10V-108

**PRODUCT CAMPAIGN BULLETIN**

**APPLICABILITY:** 2010 Tribeca  
**SUBJECT:** Front Door Latch Cable

**NUMBER:** WVO-25  
**DATE:** March 2010

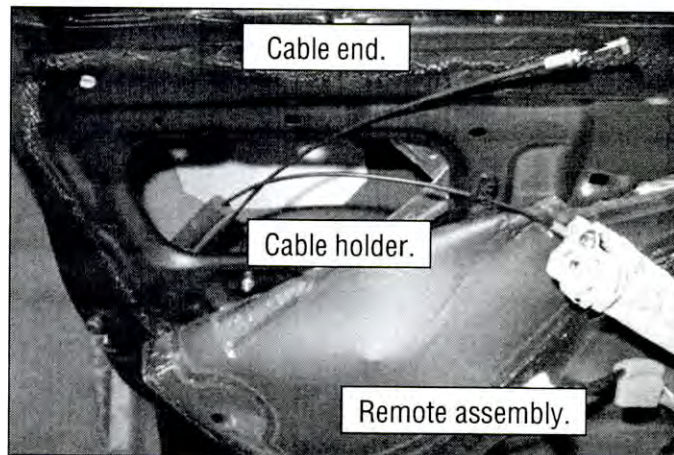
- 10) Remove the screw that secures the remote assembly and slide the assembly back to detach it from the door. Remove the upper cable from the cable holder and cable end from the remote assembly. Re-route the upper cable and position it behind the lower cable. Reinstall the cable end to the remote assembly, snap the cable back into the holder and reattach the remote assembly.

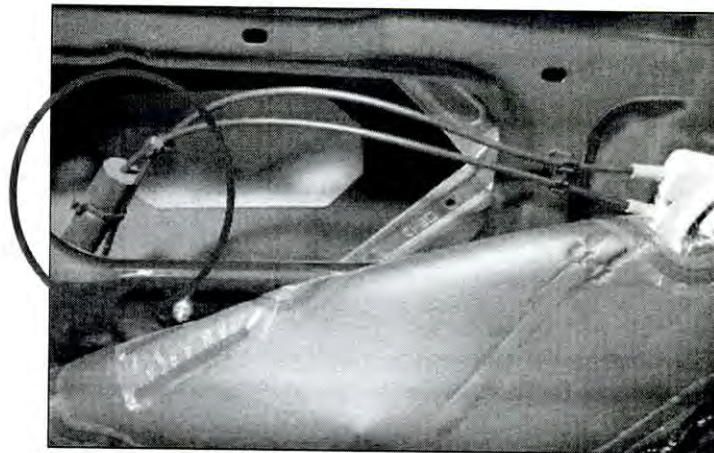
- 12) Cut off ends of tie wraps as shown.
